# Access Compliance Report

## Public Rights-of-Way

### (Curb Ramps)

Intersection ID: 54324	Main Street: BELMONT_MANSION_DR	Cross Street: ROCKY_HILL_CASTLE_DR	Location: NW
ADA ID: C576D3553029	Ramp Type: Perp	Initial Pass/Fail: Fail	Overall Compliance: No
Severity Score: 13.75			
Codes/Mitigation Info/Possible Solution		Field Measurements/Component Compliance

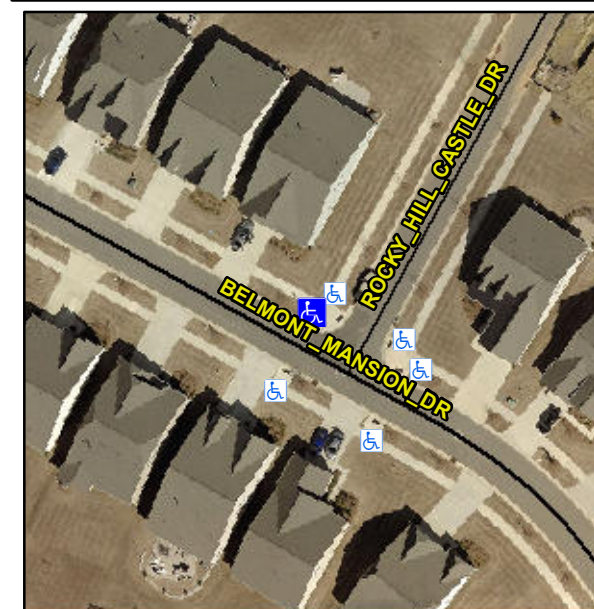
**R304.2.2**

Compliance	Description	Data	Compliance	Description	Data
N/A	Ramp Length (in)	101.0	No	Ramp Slope (%)	9.3
Yes	Ramp Width (in)	48.0	Yes	Ramp XSlope (%)	4.1
N/A	Flare Type LT	N/A	N/A	Flare Type RT	N/A
N/A	Flare Slope LT (%)	N/A	N/A	Flare Slope RT (%)	N/A
N/A	Flare Traversable LT?	N/A	N/A	Flare Traversable RT?	N/A
N/A	Landing Length (in)	N/A	N/A	DWS Provided?	N/A
N/A	Landing Width (in)	N/A	N/A	DWS Contrast?	N/A
N/A	Landing Slope (%)	N/A	N/A	DWS Length (in)	N/A
N/A	Landing X Slope (%)	N/A	N/A	DWS Full Width?	N/A
N/A	Landing Curb? (Y/N)	N/A	N/A	DWS Offset (in)	N/A
N/A	Shared Landing?	N/A			
N/A	Gutter Ponding?	N/A	N/A	Gutter Slope (%)	N/A
N/A	Gutter Lip Ht (in)	1.0	N/A	Gutter X Slope (%)	N/A
N/A	Painted X Walk1?	No	N/A	Painted X Walk2?	N/A
	X Walk 1 Direction	To SW		X Walk 2 Direction	N/A
N/A	X Walk 1 Width (in)	N/A	N/A	X Walk 2 Width (in)	N/A
	X Walk 1 Slope (%)	5.6		X Walk 2 Slope (%)	N/A
	X Walk 1 X Slope (%)	4.9		X Walk 2 X Slope (%)	N/A

**Remove & Replace Entire Ramp.**

**\$ 1850.00**
